APPLICATION NO.	FILING DATE	FIRST NAMED INVENTOR	ATTORNEY DOCKET NO.	CONFIRMATION NO.
09/849,635	05/04/2001	Sami Shemtov	551-P-002	1568
7277 Miskin & Tsui-	7590 12/16/200 <b>Yip</b> LLP	EXAMINER		
1350 Broadway	, Suite 802	DUNWOODY, AARON M		
NEW YORK, NY 10018			ART UNIT	PAPER NUMBER
			3679	
			MAIL DATE	DELIVERY MODE
			12/16/2009	PAPER

Application No.	Applicant(s)			
	09/849,635	SHEMTOV, SAMI			
Office Action Summary	Examiner	Art Unit			
	Aaron M. Dunwoody	3679			
The MAILING DATE of this communication appears on the cover sheet with the correspondence address Period for Reply					
A SHORTENED STATUTORY PERIOD FOR REPL WHICHEVER IS LONGER, FROM THE MAILING D  - Extensions of time may be available under the provisions of 37 CFR 1.1 after SIX (6) MONTHS from the mailing date of this communication.  - If NO period for reply is specified above, the maximum statutory period  - Failure to reply within the set or extended period for reply will, by statute Any reply received by the Office later than three months after the mailin earned patent term adjustment. See 37 CFR 1.704(b).	ATE OF THIS COMMUNICATION 136(a). In no event, however, may a reply be timwill apply and will expire SIX (

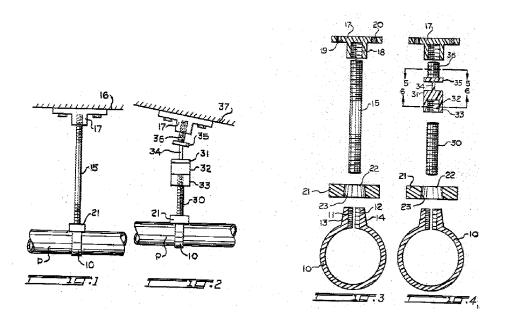
Claims 2-16, 20-35, 37, 38, 39 and 40-45 are rejected under 35 U.S.C. 102(b) as being anticipated by US patent 3493206, Albro.

In regards to claims 38, 39 and 42, in Figures 1 and 3 below, Albro discloses a combination of a coupling member (10), an electrical wire-carrying conduit (P), and a connecting member (15) for positioning and securing said conduit to a remote supporting structure having an elongated surface above said coupling member, said combination comprising:

said electrical wire-carrying conduit having opposite ends;

said coupling member receiving and supporting said conduit, said coupling member comprises a tubular member having a longitudinal axis and at least one end, said end receiving one end of said conduit along said longitudinal axis, and said tubular member having a wall containing an aperture facing the remote supporting structure above said coupling member; and

said connecting member having opposite ends, one end of said connecting member securely engaging said aperture in said wall of said tubular member, the opposite end of said connecting member extending outwardly beyond said wall and upwardly toward said remote structure, and

a clamp assembly (17), said opposite end of said connecting member engaging said clamp assembly which is adapted to securely engage the remote supporting structure selectively along its elongated surface, to securely hold and support said coupling member and said conduit in a selected position, and to be removably engagable to said remote supporting structure.

In regards to claim 2, in Figures 1 and 3 above, Albro discloses said wall is raised relative to the exterior surface of said tubular member.

In regards to claim 3, in Figures 1 and 3 above, Albro discloses said aperture is threaded internally and said end of said connecting member is externally matingly threaded for engaging into said internally threaded aperture.

In regards to claim 5, in Figures 1 and 3 above, Albro discloses a lock nut (21) along said end of said connecting member for locking said end of said connecting member into said aperture.

In regards to claim 9, in Figures 1 and 3 above, Albro discloses said tubular member further having a stop member having a round shape projects internally at about the middle of said tubular member.

In regards to claim 33, in Figures 1 and 3 above, Albro discloses said end of said connecting member is positioned within the confine of said tubular member in direct contact with said conduit.

In regards to claim 34, in Figures 1 and 3 above, Albro discloses each of said ends of said tubular member is externally threaded for receiving said conduit.

In regards to claim 35, in Figures 1 and 3 above, Albro discloses each of said ends of said tubular member further having an opening through said tubular member, said opening is internally threaded to receive a set screw for securely positioning said conduit.

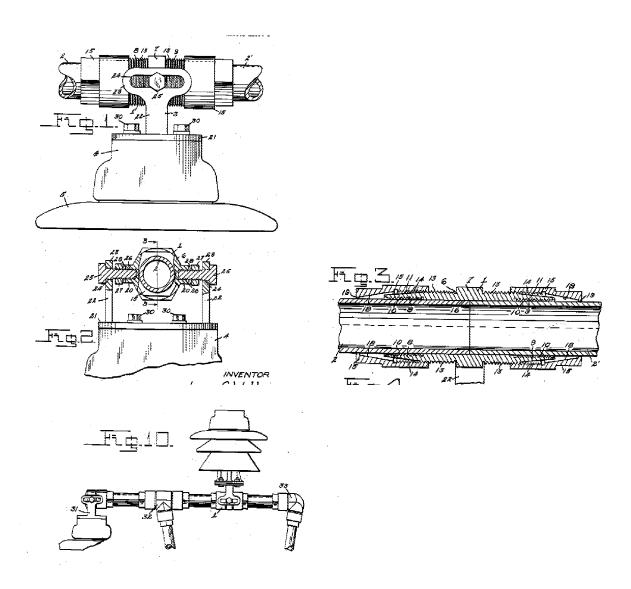
Claims 2-16, 20-35, 37, 38, 39 and 40-50 are rejected under 35 U.S.C. 102(b) as being anticipated by US patent 2246557, Walters.

In regards to claims 38, 39, 42, 46 and 50, in Figures 1-3 and 10 below, Walters discloses a combination of a coupling member (7), an electrical wire-carrying conduit (2, 2"), and a connecting member (25) for positioning and securing said conduit to a remote supporting structure having an elongated surface above said coupling member, said combination comprising:

said electrical wire-carrying conduit having opposite ends;

said coupling member receiving and supporting said conduit, said coupling member comprises a tubular member having a longitudinal axis and at least one end, said end receiving one end of said conduit along said longitudinal axis, and said tubular member having a wall containing an aperture facing the remote supporting structure above said coupling member; and

said connecting member having opposite ends, one end of said connecting member securely engaging said aperture in said wall of said tubular member, the opposite end of said connecting member extending outwardly beyond said wall and upwardly toward said remote structure, and

a clamp assembly (22), said opposite end of said connecting member engaging said clamp assembly which is adapted to securely engage the remote supporting

In regards to claim 2, in Figures 1-3 and 10 above, Walters discloses said wall is raised relative to the exterior surface of said tubular member.

In regards to claim 3, in Figures 1-3 and 10 above, Walters discloses said aperture is threaded internally and said end of said connecting member is externally matingly threaded for engaging into said internally threaded aperture.

In regards to claim 5, in Figures 1-3 and 10 above, Walters discloses a lock nut (27) along said end of said connecting member for locking said end of said connecting member into said aperture.

In regards to claim 9, in Figures 1-3 and 10 above, Walters discloses said tubular member further having a stop member having a round shape projects internally at about the middle of said tubular member.

In regards to claim 33, in Figures 1-3 and 10 above, Walters discloses said end of said connecting member is positioned within the confine of said tubular member in direct contact with said conduit.

In regards to claim 34, in Figures 1-3 and 10 above, Walters discloses each of said ends of said tubular member is externally threaded for receiving said conduit.

In regards to claim 35, in Figures 1-3 and 10 above, Walters discloses each of said ends of said tubular member further having an opening through said tubular member, said opening is internally threaded to receive a set screw for securely positioning said conduit.
